**LONG BEACH CITY COLLEGE DISTRICT
CONTRACTS MANAGEMENT DEPARTMENT**

**BID C2194A ADA SITE BARRIER REMOVAL PROJECT
AT THE
LIBERAL ARTS CAMPUS**

ADDENDUM NO # 1

OCTOBER 19, 2020

C1.24

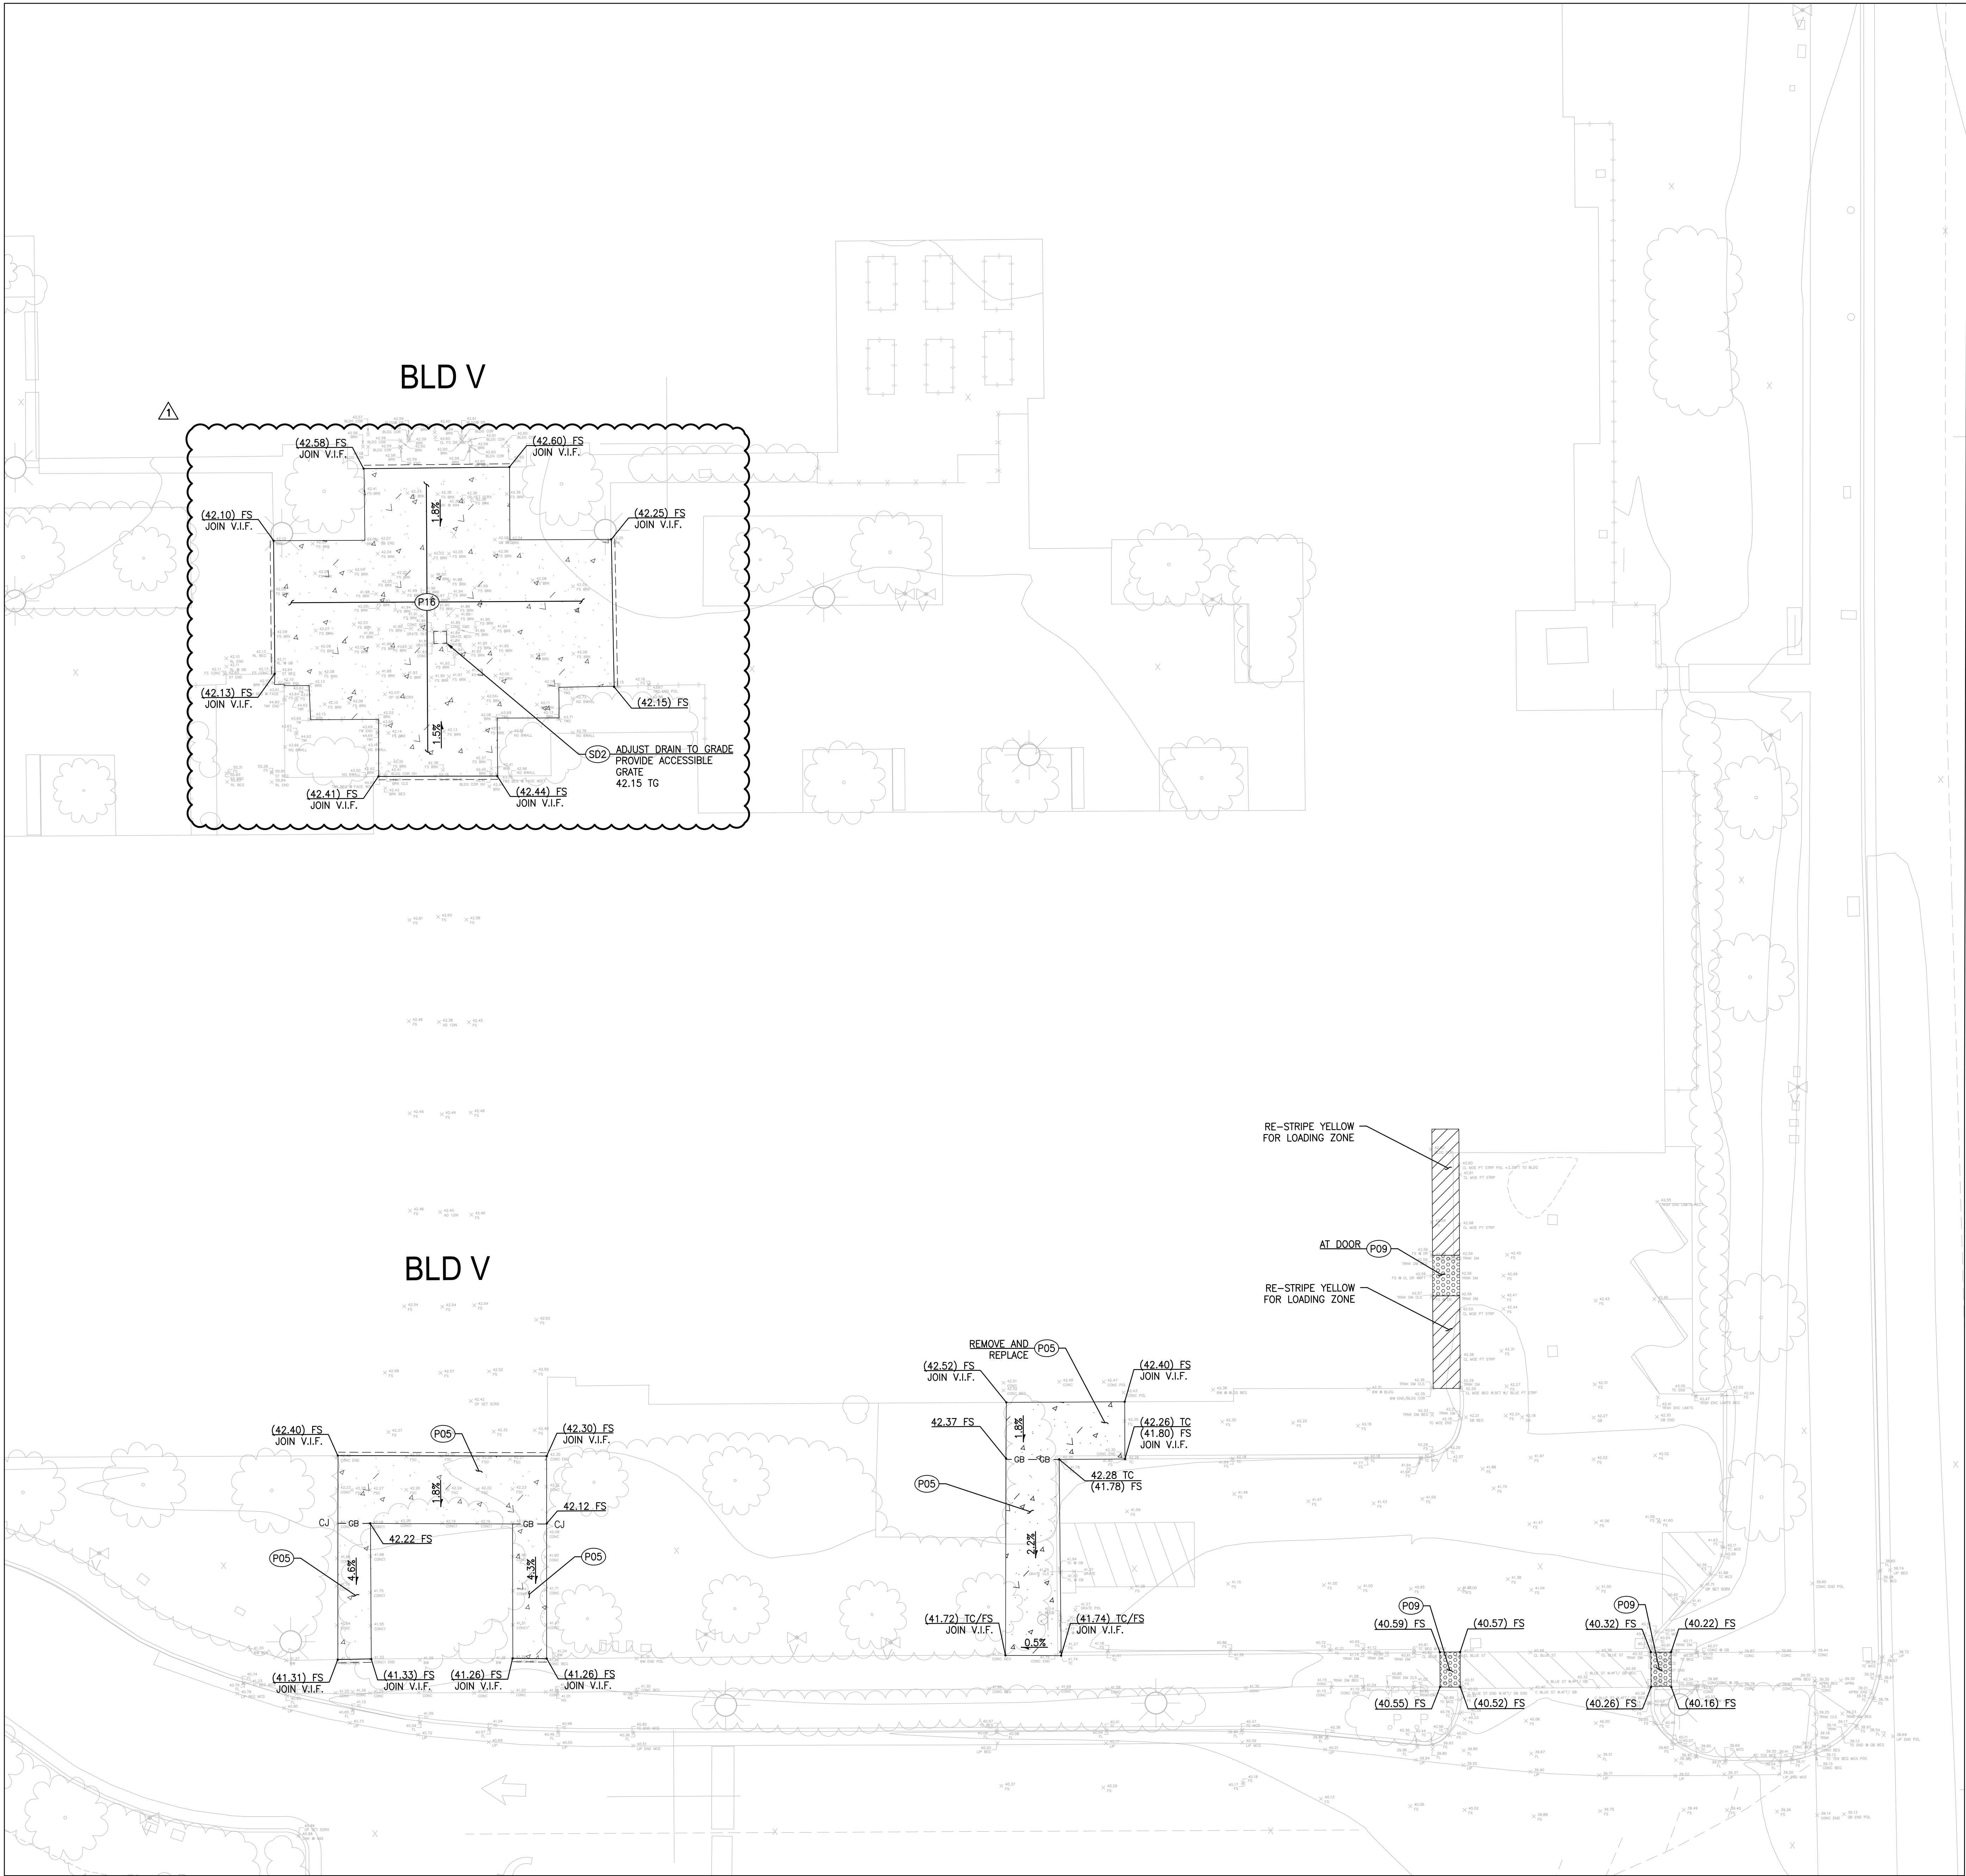
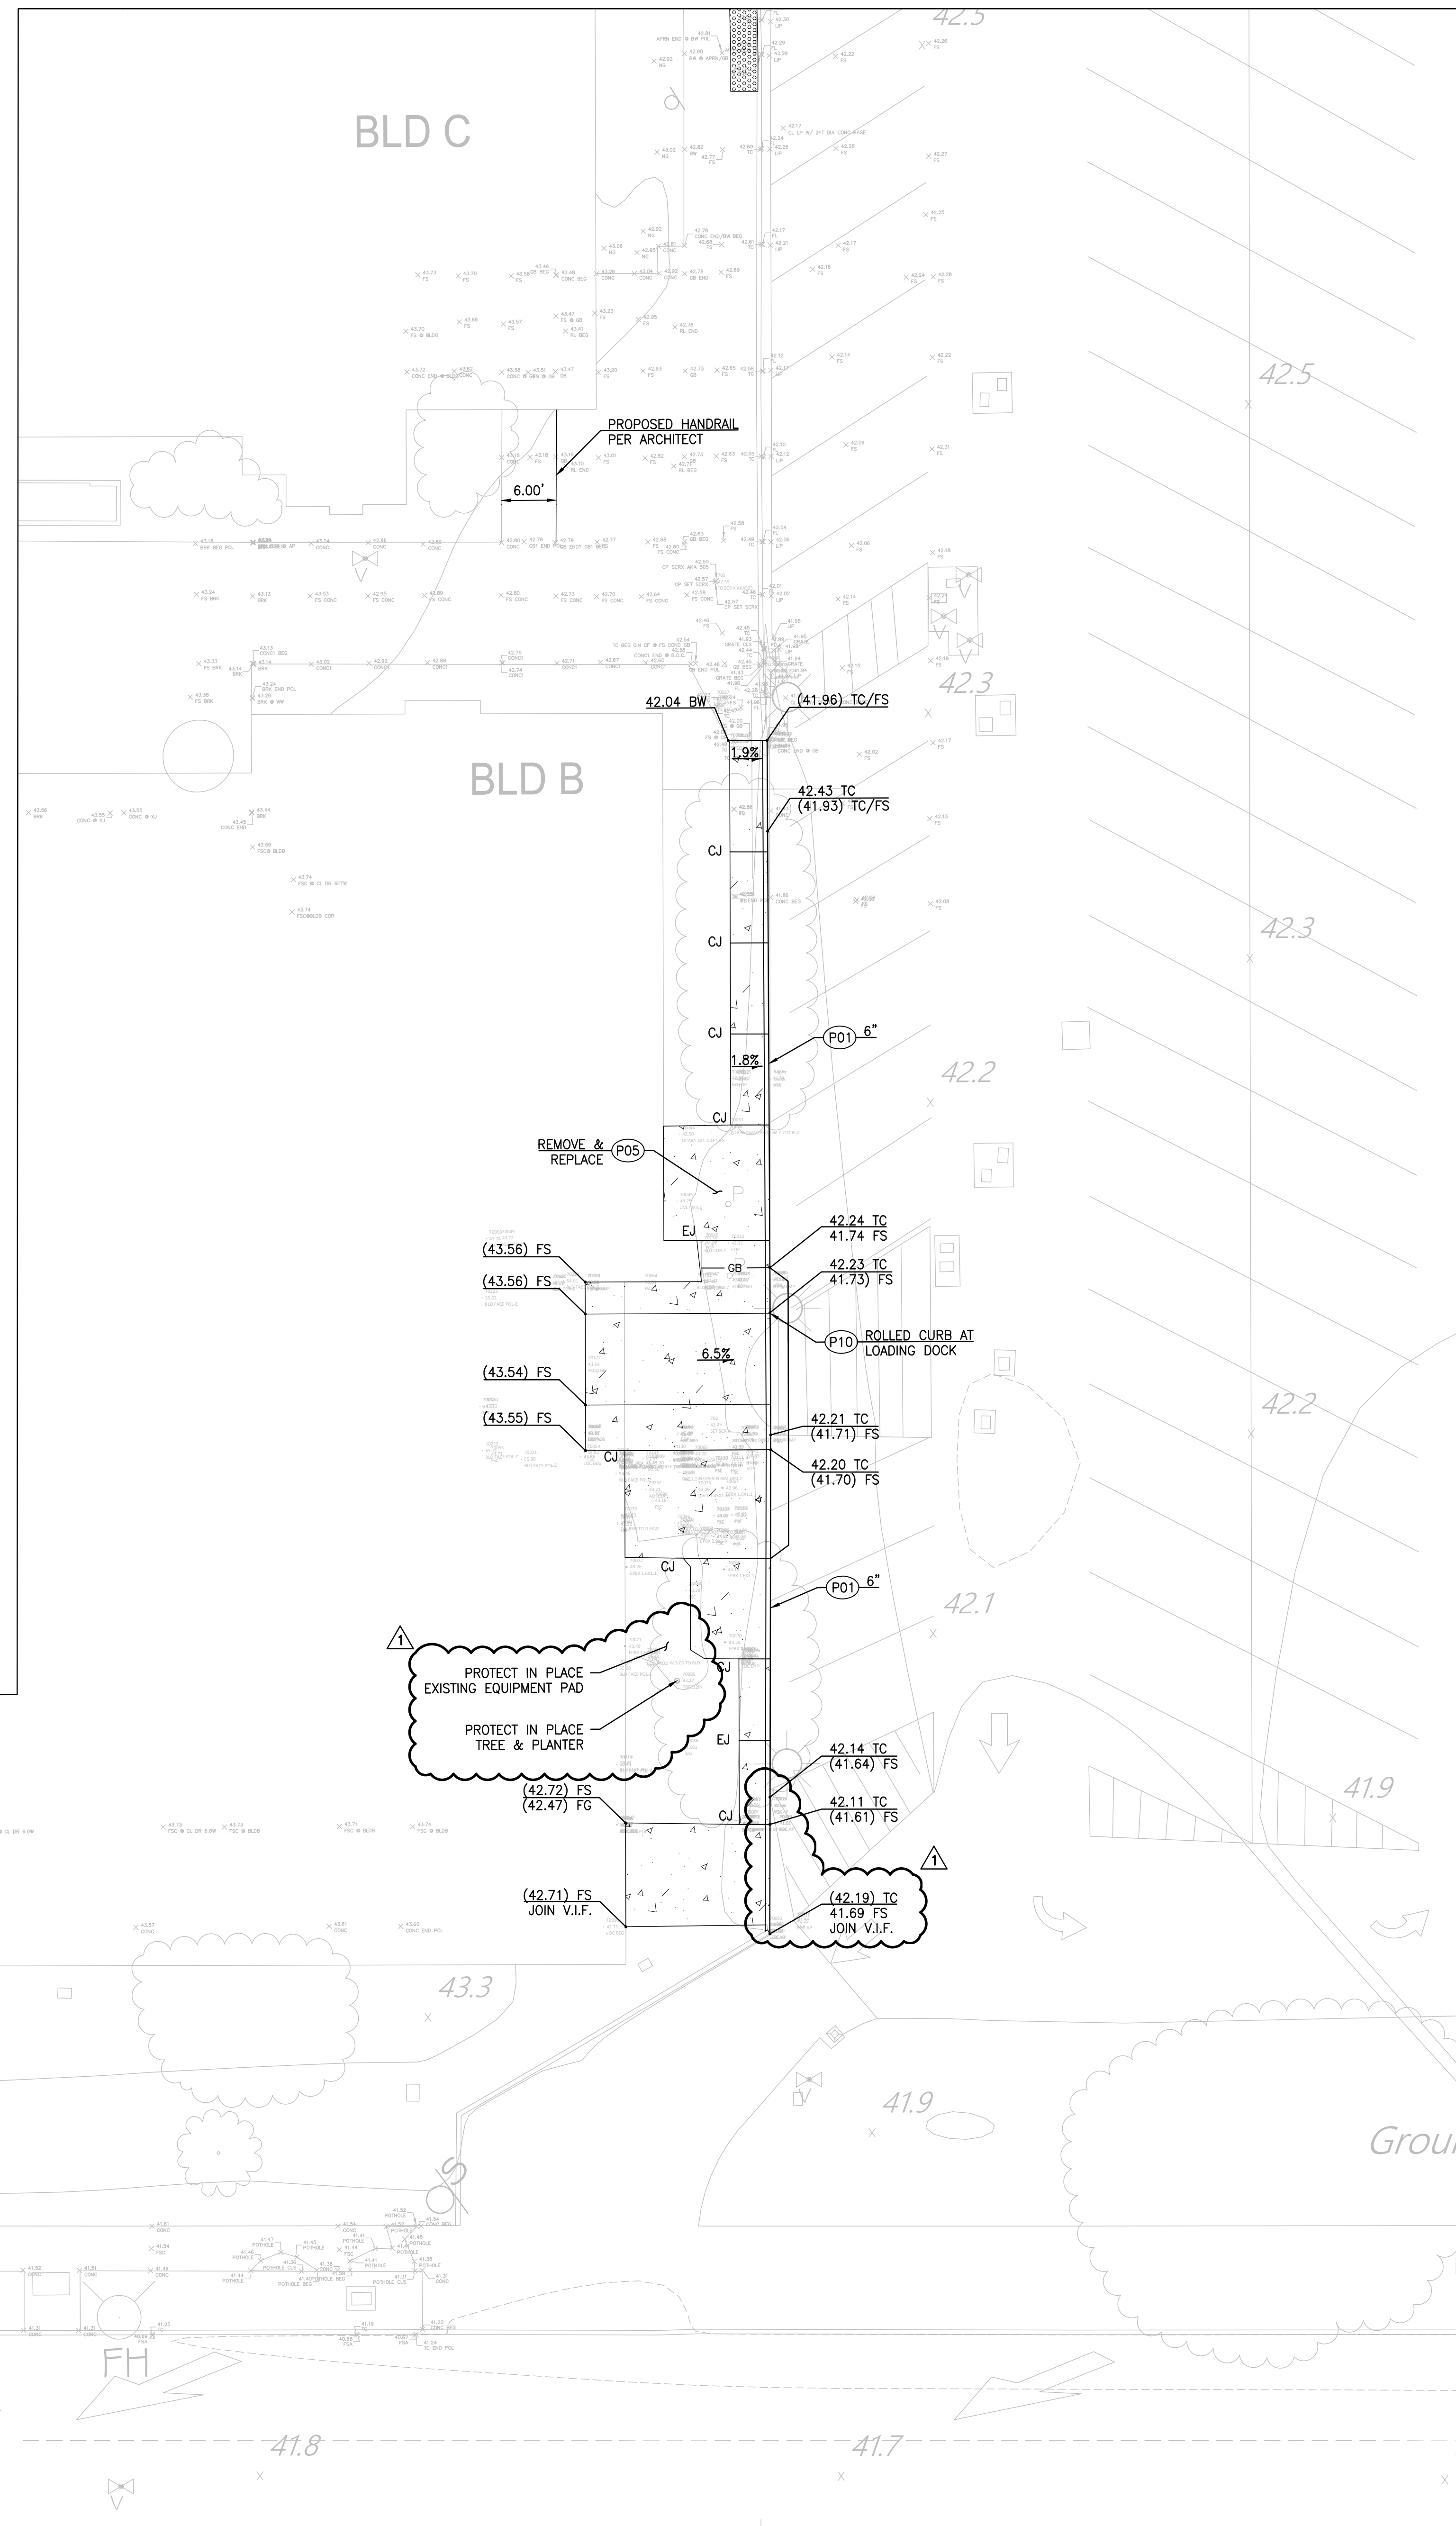
5. Q: C1.24 - In courtyard of Building S, there is existing brick. The plans show color concrete can you clarify?

A: Existing brick pavers will be removed and replaced in kind at proposed grades. See Addendum 1 Sheet C1.24.
